## AGENDA FOR REGULAR MEETING VILLAGE OF TINLEY PARK PLAN COMMISSION

May 18, 2017 – 7:30 P.M. Council Chambers Village Hall – 16250 S. Oak Park Avenue

# <u>WORKSHOP</u>: PARALLEL VERIZON CELL TOWER – 6775 PROSPERI DRIVE – SITE PLAN APPROVAL, SPECIAL USE PERMIT, AND A VARIATION FOR MAXIMUM HEIGHT

## Parallel Verizon Cell Tower Site Plan Approval & Special Use Permit

Staff's Rendering of the Proposed Cell Tower Site

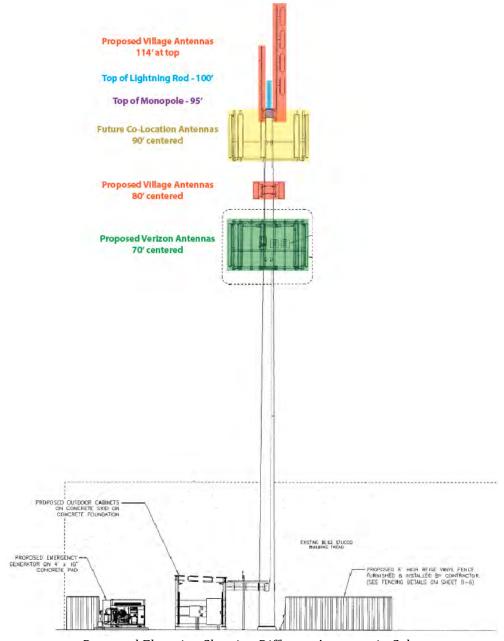
There will be an emergency generator and equipment cabinets at the base of the monopole. The Applicant has included a six foot (6') tall beige vinyl privacy fence. The Plan Commission may wish to consider requesting the Applicant increase the fence height to eight feet (8') tall to provide maximum screening of the ground equipment. The Zoning Ordinance allows up to eight foot (8') tall fencing when screening open storage (Section III.N.1.b.(5.)(a.)(iii.)). Since the intent of the Applicant's privacy fence is to screen the equipment at the base of the monopole, a taller fence will aid in achieving optimal screening.

- 1. Consider increasing the height of the vinyl privacy fence to eight feet (8').
- **2.** Update the Landscape Plan to reflect improvements to the north bufferyard per the original Landscape Plan and suggestions from the Village's Landscape Architect.
